30-46 Auburn Road, Regents Park

Peer review of Smith & Tzannes letter titled 'Review of FSR'

(PP 2016 CBANK 001 00) – 30-46 Auburn Rd, Regents Park, dated 17 April, 2020

Image: Ground Floor Plan, source: Studio MRA, August 2020

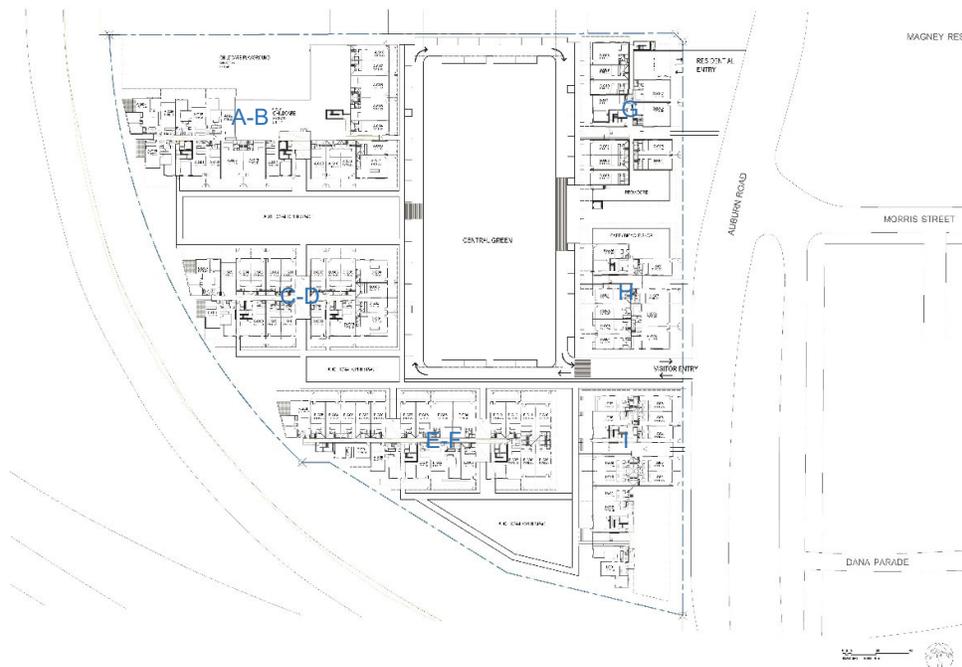
Architectus has also completed a review of this amended documentation, the results of which are provided in the Appendix to this letter as a comparison to our June 2020 review of the previous floor plans provided. While we agree with Smith & Tzannes that a planning proposal does not need to consider detailed apartment layouts, the lack of clarity and confidence provided around demonstrating that this site can adequately support the proposed density while achieving all the required amenity and design quality has led the review down this more detailed path.

Our conclusion from this review is that while some clarifications relating to ADG compliance and building envelope separation has been provided regarding the envelopes, there remains a number of outstanding ADG and urban design issues particularly related to context, built form, scale, density, setbacks from boundaries, building articulation, sustainability and amenity that have not been addressed or resolved by the Proponent or in the independent review by Smith & Tzannes, and will impact on the maximum FSR and height of buildings sought. We are also doubtful that the revised detailed floor plans can achieve ADG compliance as claimed, particularly when assessed on a building by building basis, as required by the ADG Design Criterion. For example, Architectus is largely concerned that a high number of apartments on the western side of the site (housing up to nearly 70% of the entire site's yield under the current proposal) fail to meeting ADG's solar access requirements. A number of these ADG issues associated with the amended plans are evaluated and outlined in the Appendix of this review.

Option 1a – FSR 1.75:1 (Council FSR recommendation) *(Adapted from McGregor Coxall proposal – 22.4m deep footprints, maximum 8 storeys)*

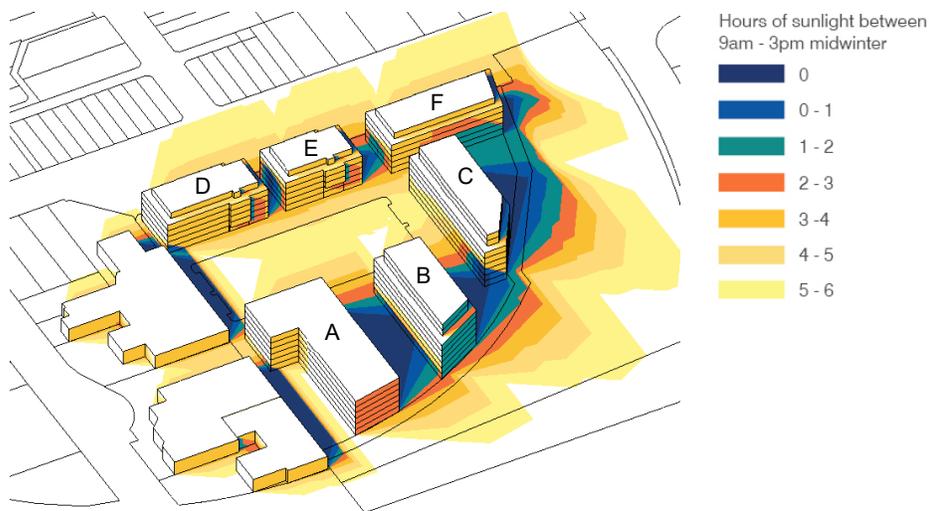
- Increasing setbacks to building envelopes perpendicular to the existing rail line. Setback increased from 3 metres to 6 metres along the train line.
- Providing upper level setbacks to reduce perceived scale and increase vertical articulation.
- Ensuring a transition to lower scale development with a 5-storey street wall along Auburn Road and an upper level storey, set back 3 metres to all sides to minimise visual impact.
- Building height A reduced to 6 storeys to maintain solar access to northern face of Building B.
- Results in an FSR of 1.77:1 (using 80% efficiency as per yield figure (Gross Building Area to Gross Floor Area) recommended in McGregor Coxall's peer review addendum dated 9 October, 2019). *Note: using 76% efficiency as recommended in Architectus' response to the McGregor Coxall review, dated 18 December, 2019, results in an FSR of 1.68:1 for this option).*

Option 1b - FSR 2:1 (Amended Gateway determination) (Adapted from McGregor Coxall proposal – 22.4m deep footprints, maximum 12 storeys)

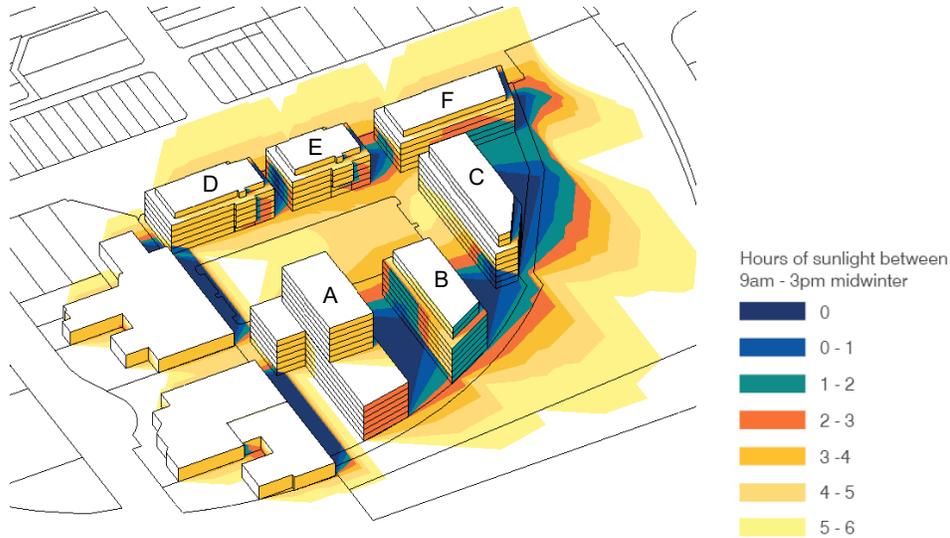
- Items as per Option 1a.
- Limiting 12 storey portions of envelope to the north-west corner of the site only to minimise solar access impact to buildings. Despite this, solar access is compromised to Building A-B and is unlikely to comply with minimum solar access requirements for this building.
- Results in an FSR of 1.95:1 (using 80% efficiency). (Or 1.85:1 using 76% efficiency).

- The study completed by Architectus demonstrates that a density of 2:1 still requires built form to be over 8 storeys (28m), which is inconsistent with council's strategy for height in areas away from local centres.

Alternative Proposal

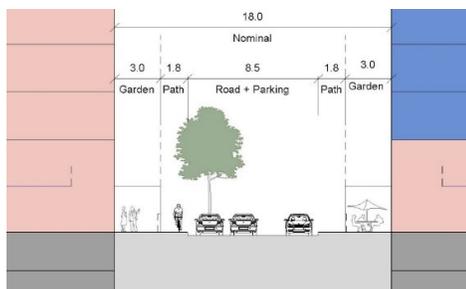
- An alternate built form configuration for the site adapted from the McGregor Coxall proposal to accommodate an FSR of 2.4:1 was proposed in the letter by Smith & Tzannes. Architectus note that under this alternative proposal, the dominant building envelope depth is 18 metres and that the decreased width means that an additional envelope can be accommodated on the site. A detailed ADG analysis of the alternative proposal is provided in *Section 3: ADG Assessment below*, however the strategic issues which will influence appropriate amenity outcomes and maximum FSR area discussed below.

- While the alternative proposal by Smith & Tzannes maintains the 6m setback to Auburn Road as per Council's recommendation, they have reduced the recommended 6m setback along the railway corridor to 3m. This, they claim, will allow the objective of appropriate landscaping and substantial deep soil planting. However as per Part 3E of the ADG, a minimum 6m depth is required for deep soil zones on sites greater than 1,500sqm. In addition, as per our previous advice on building setbacks, providing generous setbacks is also important to maintain appropriate amenity protection from adjacent land uses (i.e. industrial, rail and major road), and allow for potential shared cycle paths.

- The alternative proposal fails to provide upper level setbacks along Auburn Road to create an appropriate scale transition to the area of low density across Auburn Road. It also fails to provide an appropriate level of upper level setbacks to built form within the precinct to mitigate the scale of the development to the public domain and create vertical articulation.

- Within this alternative proposal, building separation was decreased to 18m. Architectus has assessed this 18 metre separation and agrees that it is an appropriate minimum separation to achieve the required building separation distances as per Part 2F of the ADG, and can accommodate a shared access way for vehicular access to enable vehicular drop off points to each future building entry and a turning circle at the end of each road. It also allows for private open space at ground floor and potential deep soil planting as per the indicative section below:

Option 2a – FSR 1.75:1 (Adapted from Smith & Tzannes alternative proposal – 18m deep footprints, maximum 8 storeys)

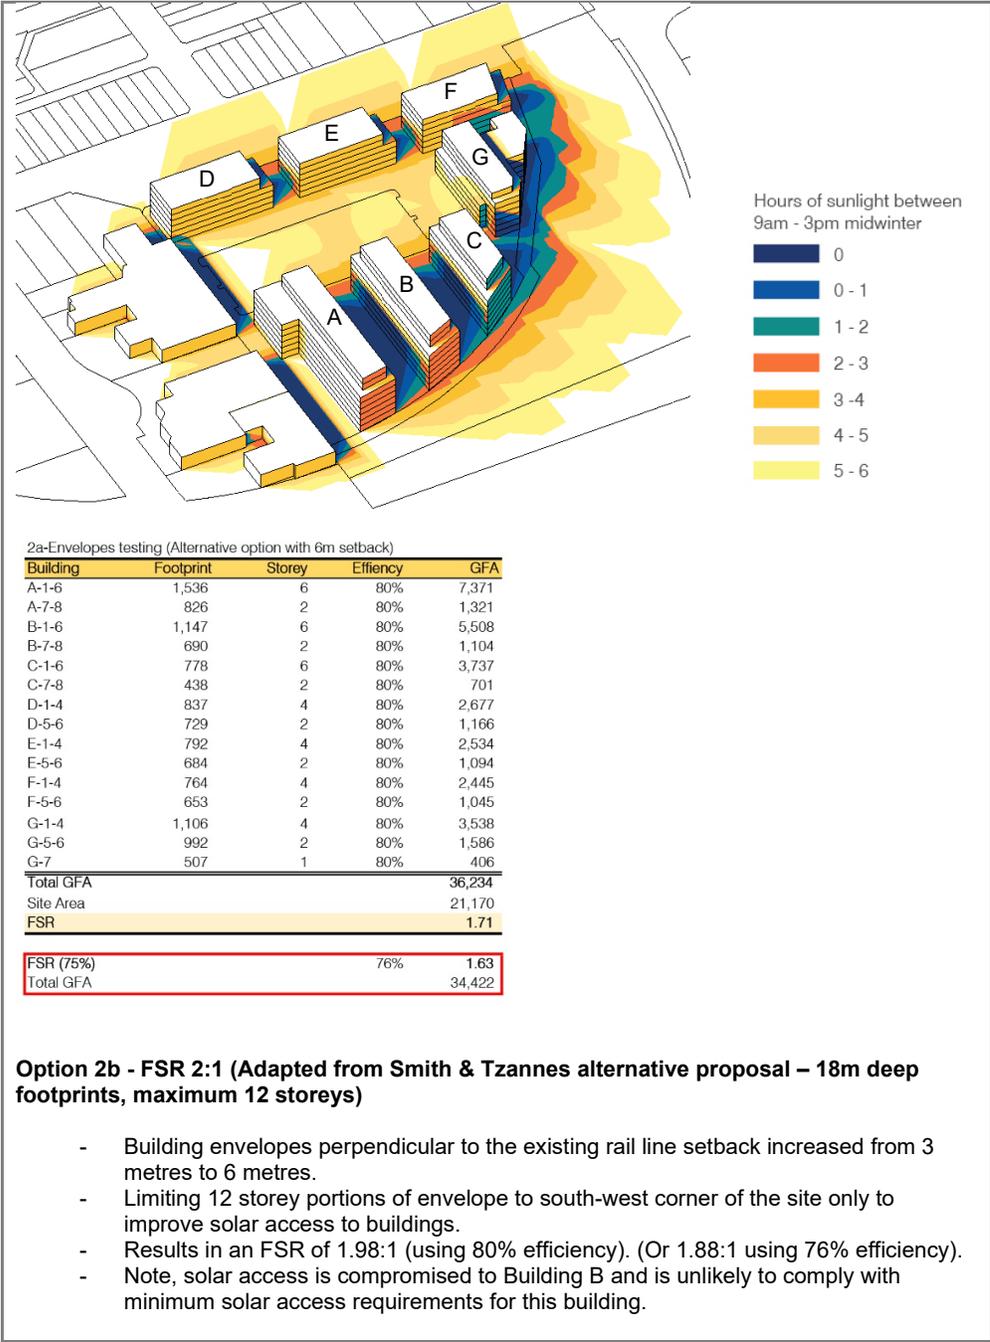
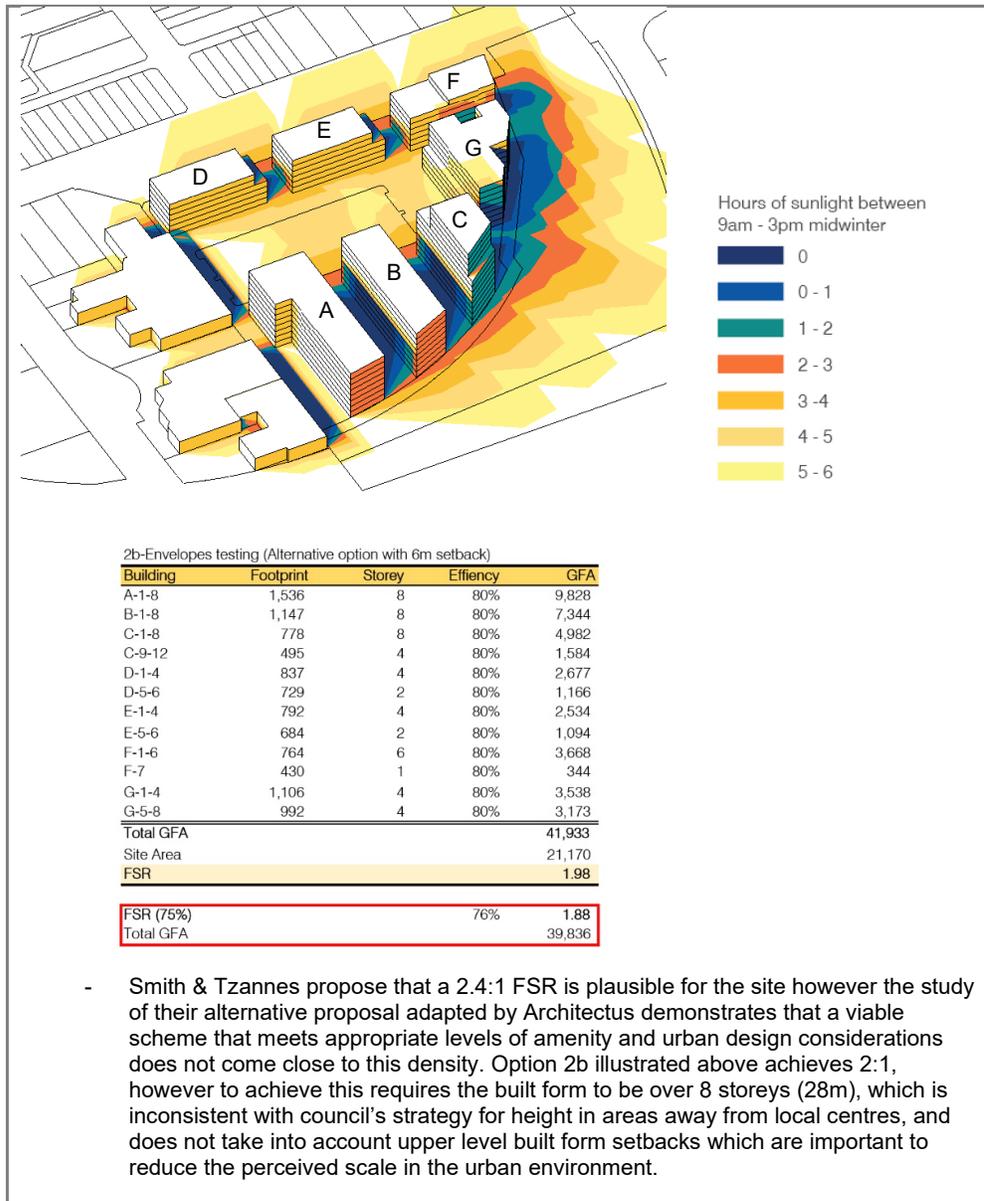
- Building envelopes perpendicular to the existing rail line setback increased from 3 metres to 6 metres.
- Building envelopes with a maximum of 8 storeys height limit, comprising a street wall of 6 storeys with upper level setbacks of 3 metres to all sides.
- Results in an FSR of 1.71:1 (using 80% efficiency). (Or 1.63:1 using 76% efficiency).
- Note, solar access is compromised to Buildings B and C and is unlikely to comply with minimum solar access requirements for these buildings.
